# Access Compliance Report

## Public Rights-of-Way

### (Curb Ramps)

Intersection ID: 46575	Main Street: ATKINS_CIRCLE_DR	Cross Street: JOHNSTON_RD	Location: NW
ADA ID: FE566B239EC9	Ramp Type: PerpDiag	Initial Pass/Fail: Fail	Overall Compliance: No
Codes/Mitigation Info/Possible Solution		Field Measurements/Component Compliance	
Severity Score: 8.75

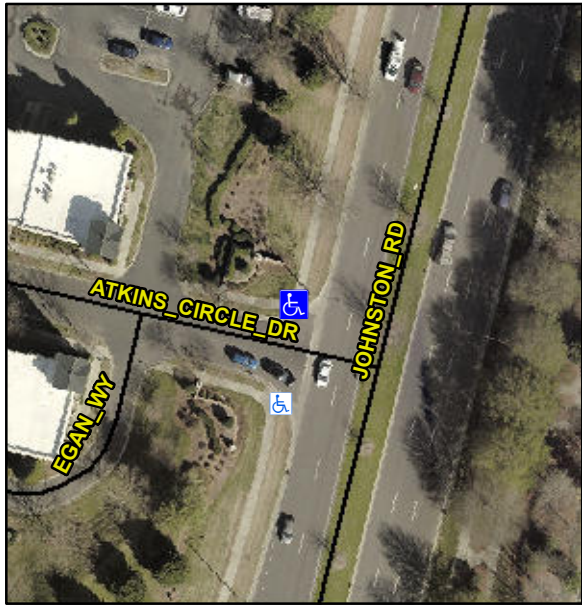
Not Found, R304.5.1

Compliance	Description	Data	Compliance	Description	Data
N/A	Ramp Length (in)	55.0	Yes	Ramp Slope (%)	5.1
No	Ramp Width (in)	40.0	Yes	Ramp XSlope (%)	1.6
N/A	Flare Type LT	N/A	N/A	Flare Type RT	N/A
N/A	Flare Slope LT (%)	N/A	N/A	Flare Slope RT (%)	N/A
N/A	Flare Traversable LT?	N/A	N/A	Flare Traversable RT?	N/A
N/A	Landing Length (in)	N/A	N/A	DWS Provided?	N/A
N/A	Landing Width (in)	N/A	N/A	DWS Contrast?	N/A
N/A	Landing Slope (%)	N/A	N/A	DWS Length (in)	N/A
N/A	Landing X Slope (%)	N/A	N/A	DWS Full Width?	N/A
N/A	Landing Curb? (Y/N)	N/A	N/A	DWS Offset (in)	N/A
N/A	Shared Landing?	N/A			
N/A	Gutter Ponding?	N/A	N/A	Gutter Slope (%)	N/A
N/A	Gutter Lip Ht (in)	N/A	N/A	Gutter X Slope (%)	N/A
N/A	Painted X Walk1?	No	N/A	Painted X Walk2?	No
	X Walk 1 Direction	To SW		X Walk 2 Direction	To SE
N/A	X Walk 1 Width (in)	N/A	N/A	X Walk 2 Width (in)	N/A
	X Walk 1 Slope (%)	3.4		X Walk 2 Slope (%)	3.8
	X Walk 1 X Slope (%)	6.1		X Walk 2 X Slope (%)	3.0

Remove & Replace Curb Ramp With Two New Directional Ramps or Equivalent.
